**MAINE MEDICAL CENTER'S  
CHARLES STREET ADDITION  
VICINITY  
OF  
BRAMHALL, CONGRESS AND GILMAN STREETS**

**CONDITIONAL USE REVIEW FOR EXPANSION OF A HOSPITAL  
CONDITIONAL USE REVIEW FOR A USE REPLACING HOUSING  
HOUSING REPLACEMENT PLAN REVIEW  
SITE PLAN REVIEW  
SITE LOCATION OF DEVELOPMENT REVIEW  
RECOMMENDATION(S) TO CITY COUNCIL RE: STREET VACATION, ACCEPTANCE AND  
LAND TRANSFER PLAN**

**MAINE MEDICAL CENTER, APPLICANT**

Prepared by: Rick Seeley, Senior Planner, GPCOG,  
Consultant to the City Planning Division  
May 27, 2005

Drawn By	WMC	Scale	1"=20'	Sheet Number	28/29/04
Approved By	WMC	Revision	01/04/04	PKG-C	C401

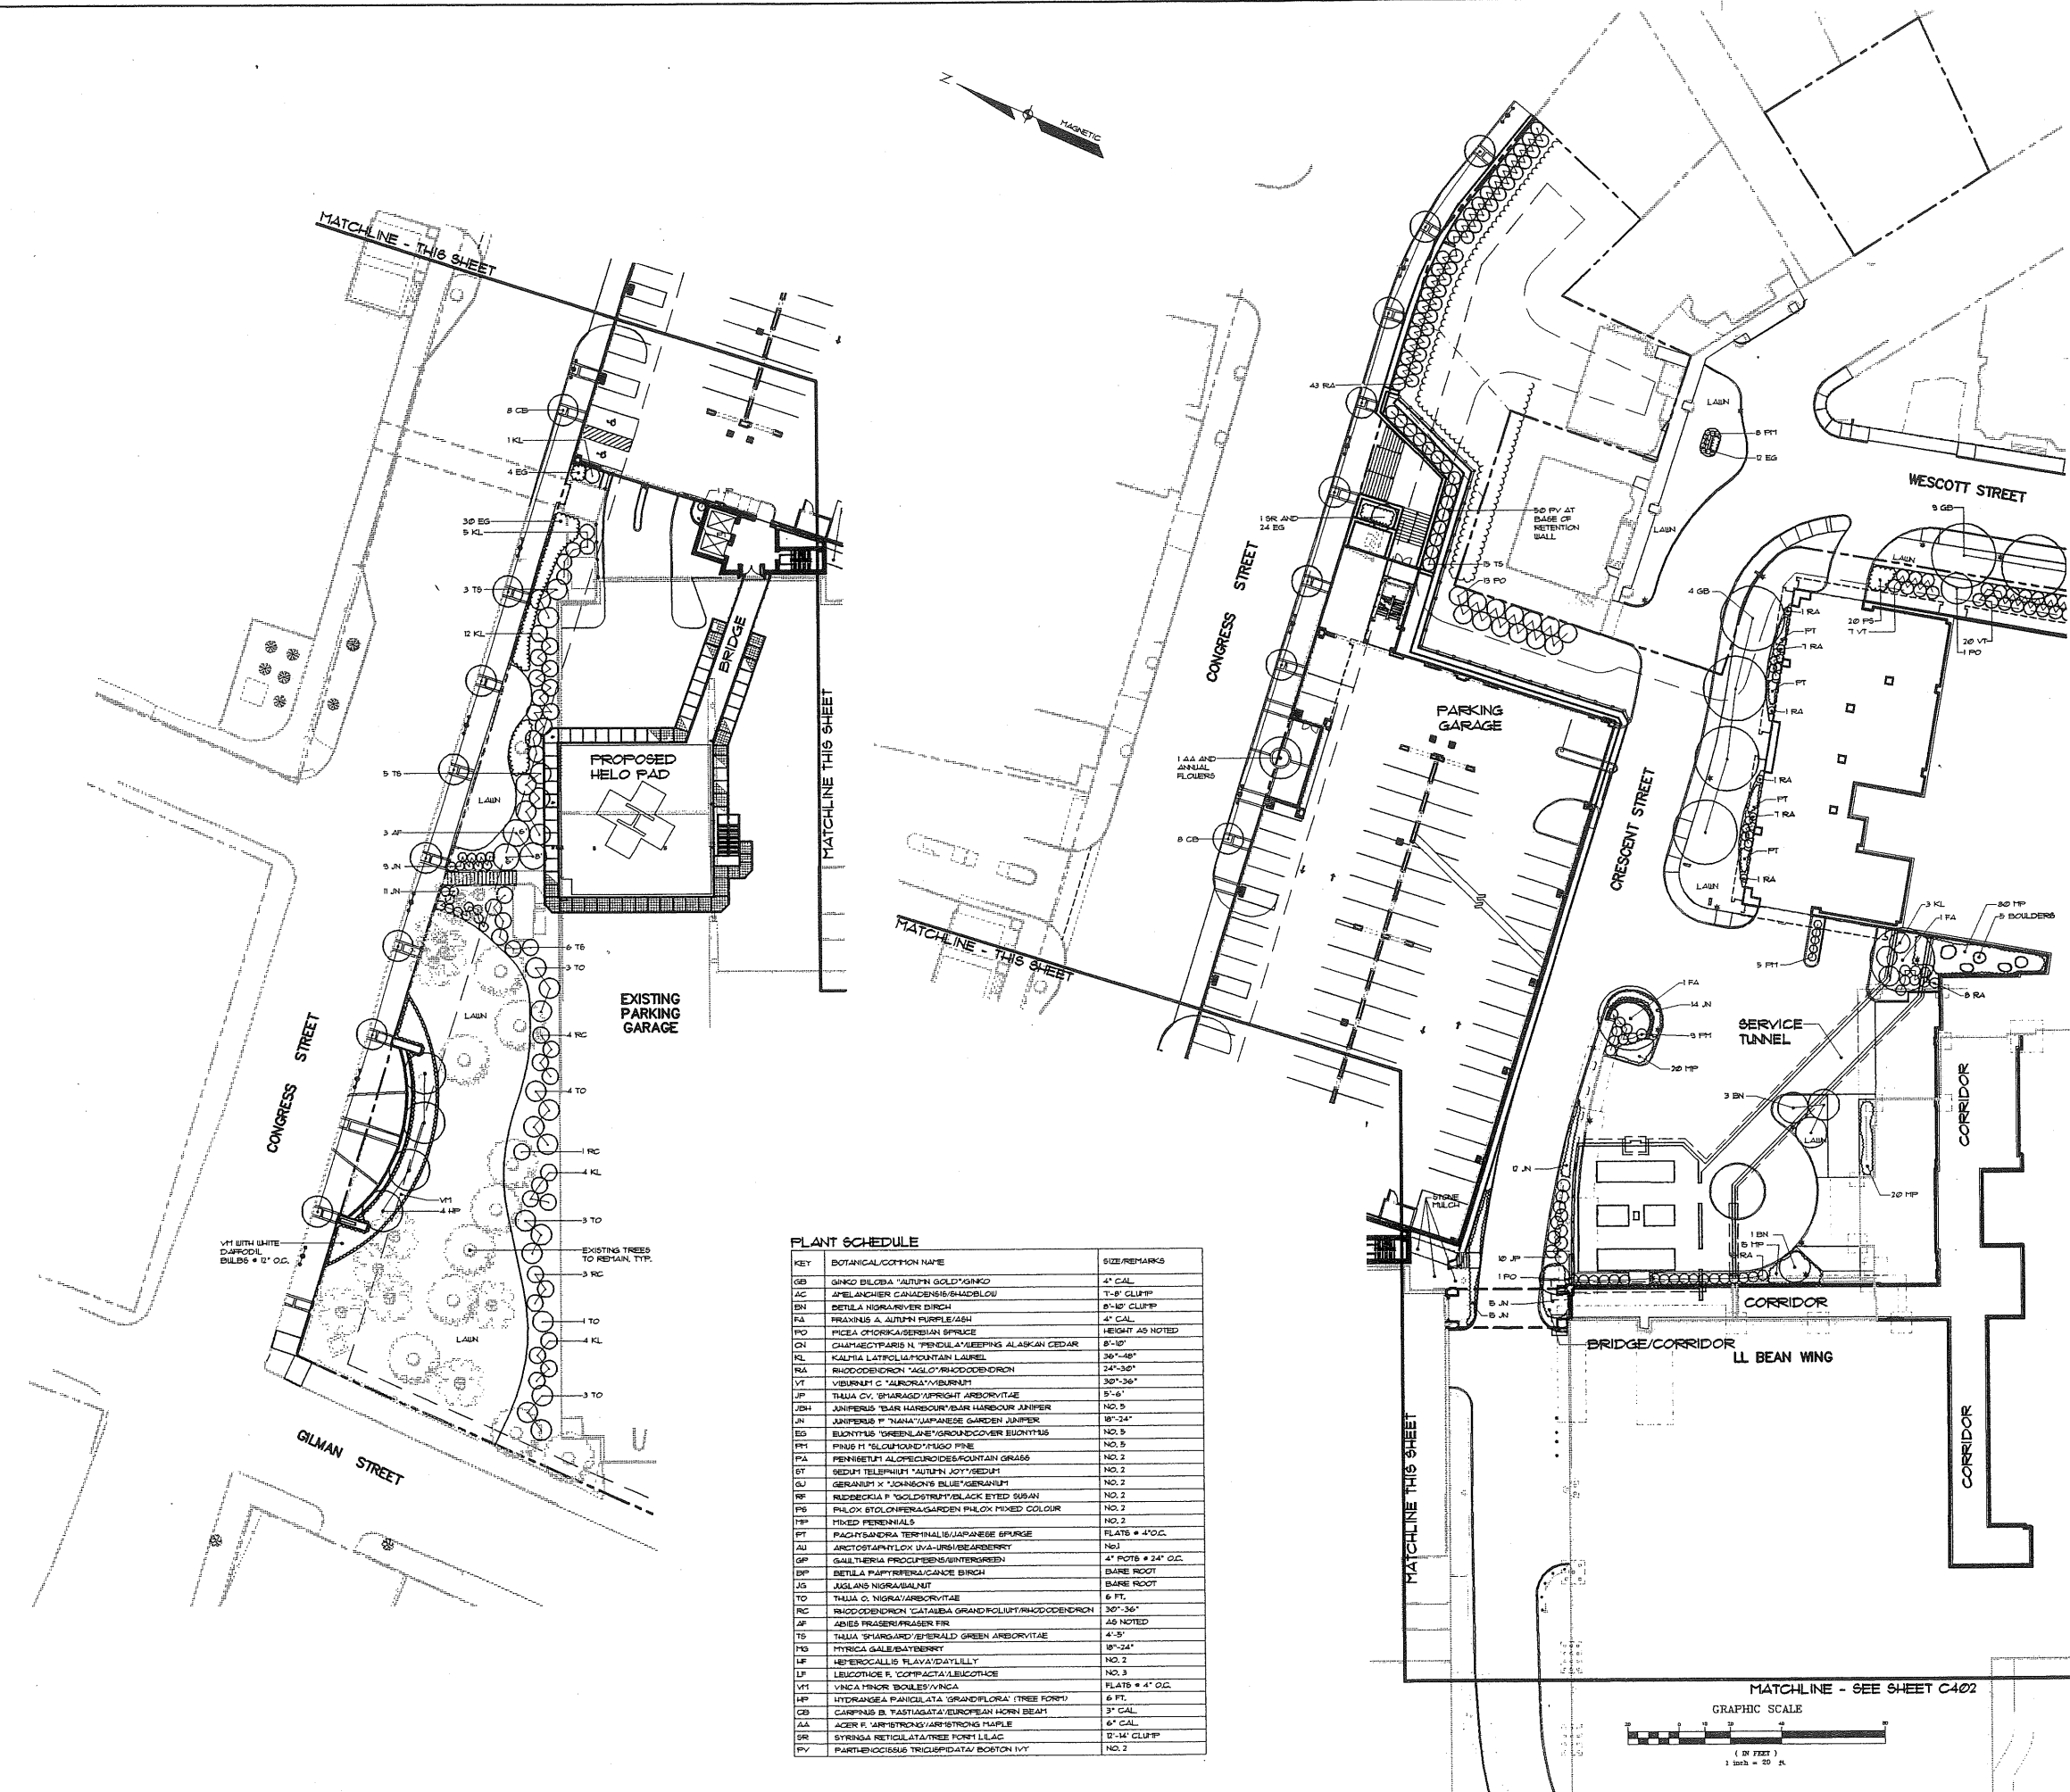
For the most part the plans include replacement of disturbed vegetation with landscaping or construction. The landscaping behind the saved trees areas delineated on the Gilman Street landscaping plan is somewhat indefinite though, and the City Arborist recommends better definition of the plan in this steeply sloped area, and consultation with City Arborist to best determine how to replace what is shown on the plan as to be removed.

The Plan does not address protection of vegetation from further erosion along existing desire lines worn into the grass near the top of Gilman Street.

- iv. MMC shall follow the recommended landscape plan improvements recommended by the City Arborist in his review memo dated May 27, 2005, but shall not be required to place a sidewalk along the edge of the Gilman Street curve, as described therein.
